SUBJECT: Addendum to RFB 071824-01 – Camp Dodge Building A-01 Latrine Renovations

ADDENDUM # 1

RE: Addendum No. 1 to the Bidding Documents for:
BUILDING A-1 RENOVATE LATRINES
Schemmer Project No. 08320.001

P102

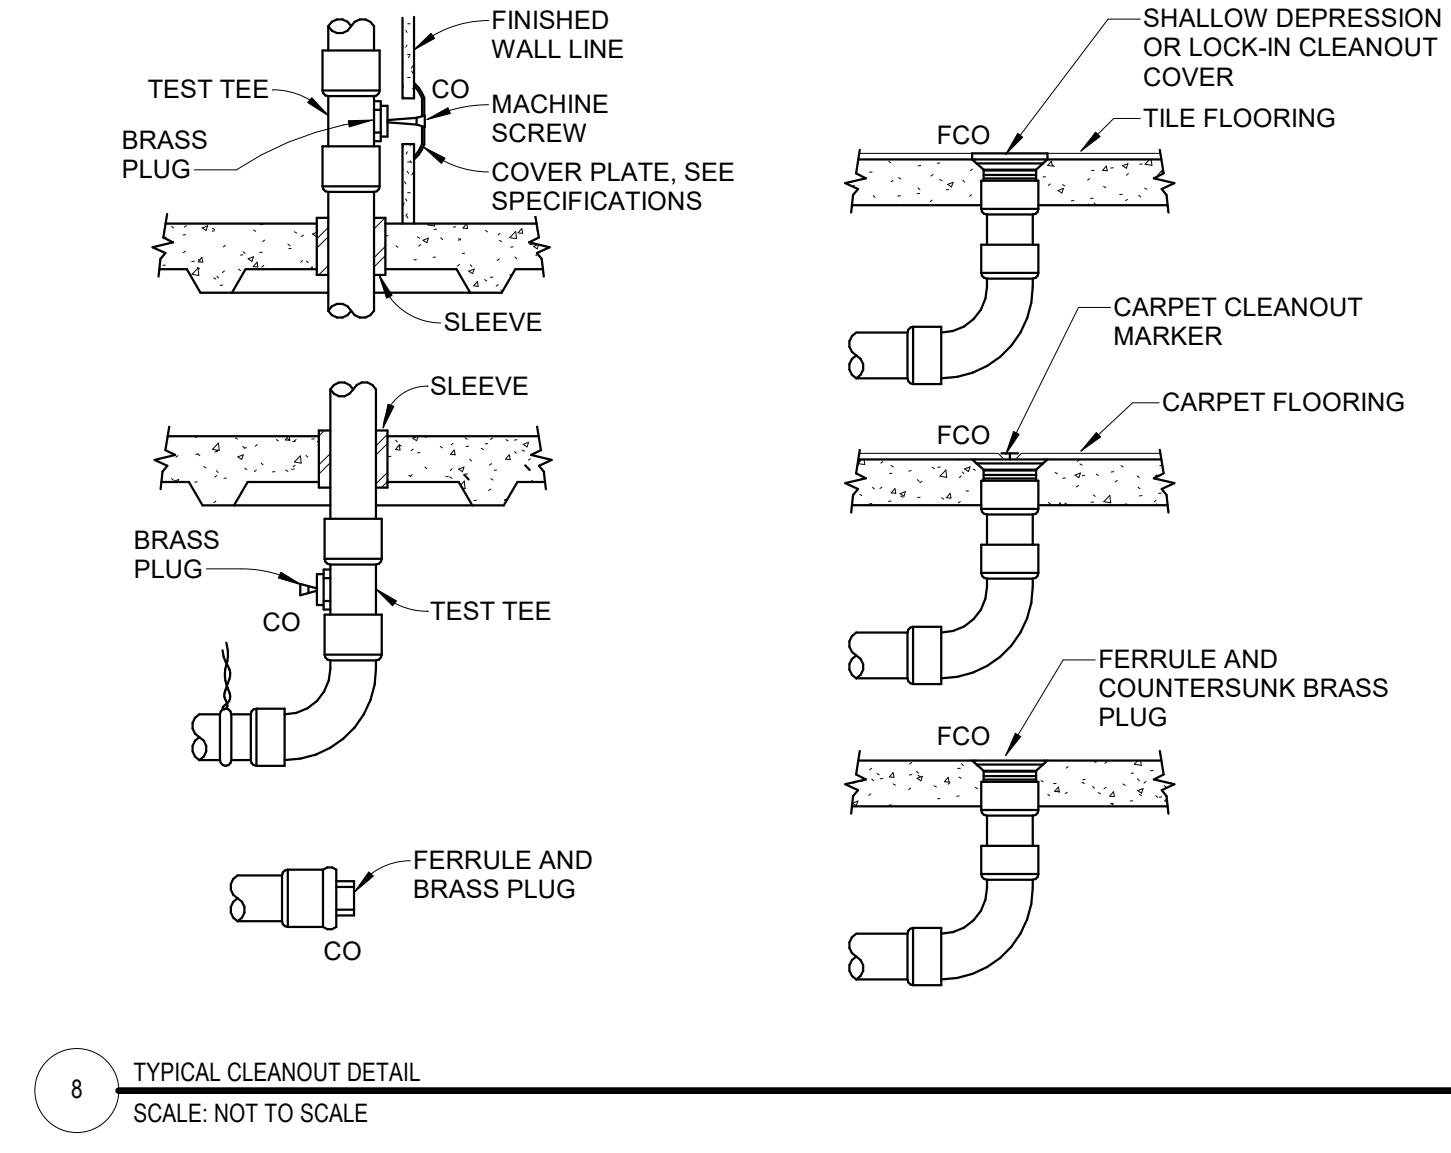
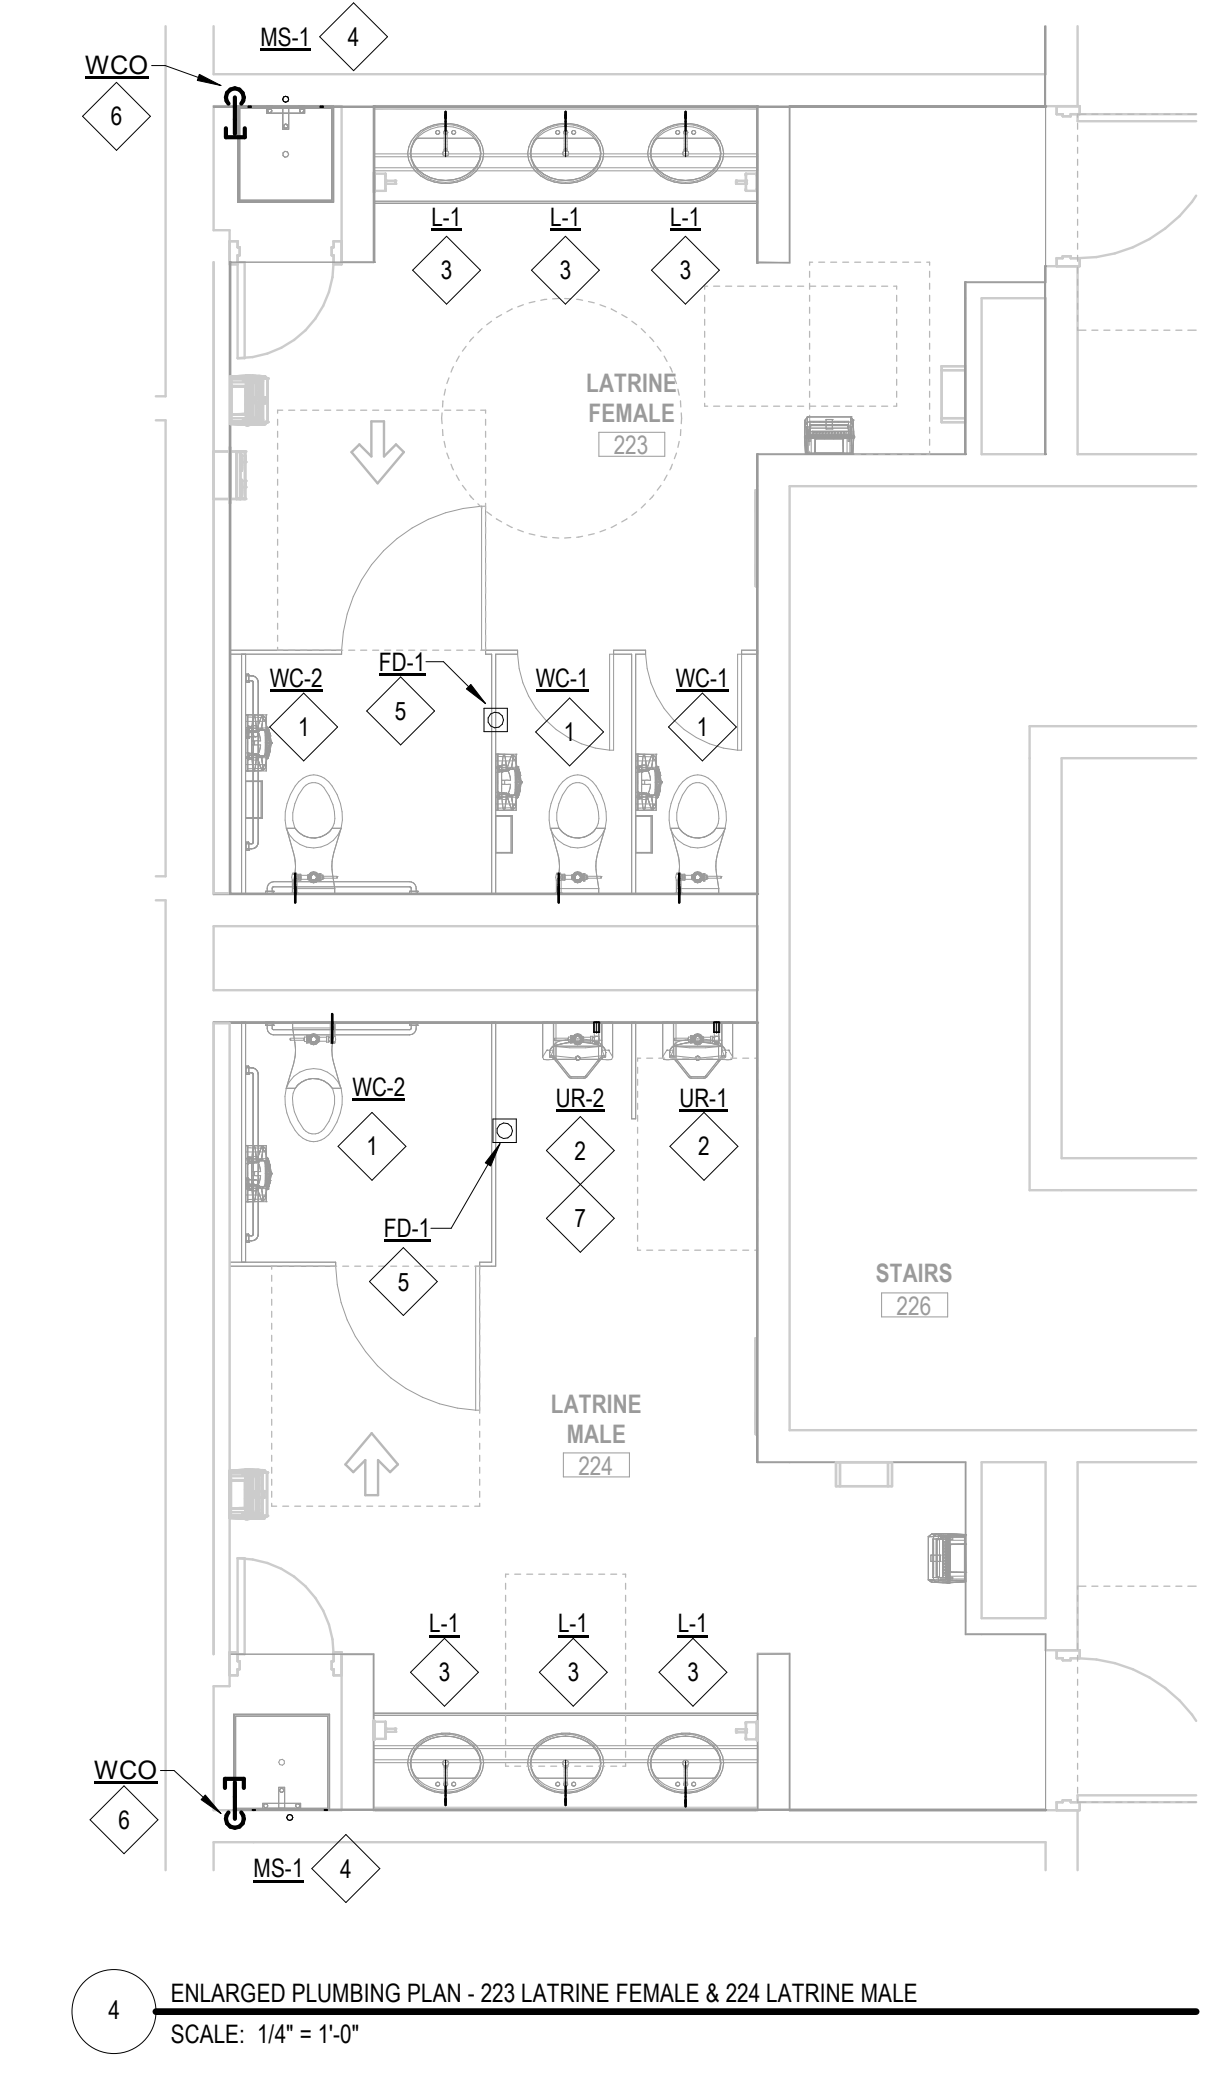
Item No. DP-1, Sheet P102 SECOND FLOOR – PLUMBING

Detail 9/P102 has been removed.
